Note on Terminal Capacity Targets and Incentive Schemes

Figure 1: RP3 Terminal incentive scheme parameters

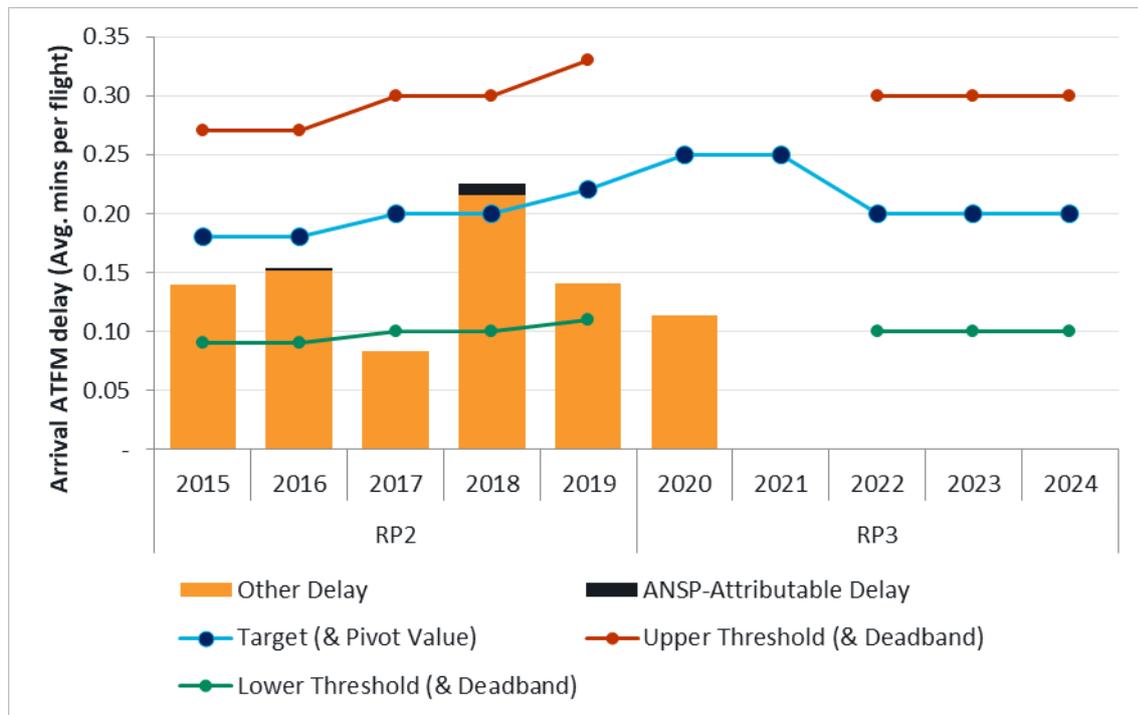
- 1.3 Firstly, the European Commission has found that the proposed RP3 targets for the average arrival ATFM delay ranging from 0.20 to 0.25 minutes per flight for calendar years 2021 to 2024 are 'significantly higher' than the achieved ATFM delay performance in all but one calendar year of the second reference period ('RP2'), with an average arrival ATFM delay of approximately 0.15 minute per flight observed during that period. The Commission would like Ireland to further justify these targets, or to revise them downwards.

1.8 Secondly, the Commission has expressed concerns over the fact that both the En Route capacity incentive scheme and the Terminal capacity incentive scheme proposed in Ireland's draft performance plan each comprise a maximum financial disadvantage amounting to 0.5% of determined costs. The Commission doubts that the proposed maximum financial disadvantage would have any material impact on the revenue at risk, as required pursuant to Article 11(3), point (a) of Implementing Regulation (EU) 2019/317. Therefore, it argues that Ireland should revise its incentive schemes so that the maximum financial disadvantages stemming from the schemes are set at a level having a material impact on the revenue at risk, which in the Commission's view should lead to a maximum financial disadvantage equal to or higher than 1% of determined costs.

- 1.4 In response to this point we note that in the RP3 Performance Plan, the terminal capacity targets for 2022 to 2024 are set at a level consistent with the average annual terminal delay targets in RP2, at 0.20 minutes. We have not reassessed the 2020/2021 targets as these years have already passed.

- 1.5 In 2020, despite lower levels of traffic, the average minutes of actual ATFM delay per arrival at Dublin airport was only slightly lower than most years in RP2 and remained at a broadly consistent level. This delay was attributed to the same causes as the vast majority of RP2 delay (weather and aerodrome capacity). For an overview of RP2 targets and delay, and RP3 targets, see figure 1 below. Therefore, given that the level of arrival ATFM delay has remained broadly unchanged notwithstanding the traffic reduction, and that nearly all of the delay in RP2 was not attributable to the ANSP, we saw no reason to revise these targets relative to the original RP3 Performance Plan developed in 2019. It is important that the ANSP avoid any material dis-improvement in performance, and we are seeking to achieve this, rather than trying to promote further improvement, as we believe there is very little scope remaining for the ANSP to do so.

- 1.6 We believe that more ambitious targets would instead be more likely to result in the ANSP failing to achieve the targets for events outside of its control, as was the case in 2018. For example, if the target had been set to 0.15 minutes during RP2, this would have additionally resulted in the ANSP not meeting the target in 2016, for reasons not within its control.

- 1.12 For Terminal, as shown above, the ATFM arrival delay attributable to the ANSP was at or close to zero. It would therefore not be reasonable to set a target seeking further improvement which would penalise the ANSP for factors outside its control. Nor would it be reasonable to have any bonuses, as there is little scope remaining for improvement in delay performance of the ANSP. While the pivot value can be modulated based on ANSP-attributable delay, the deadband and threshold are based on all delay causes; it is therefore not possible to implement a properly ANSP-attributable delay incentive scheme, which would be more appropriate in this case.
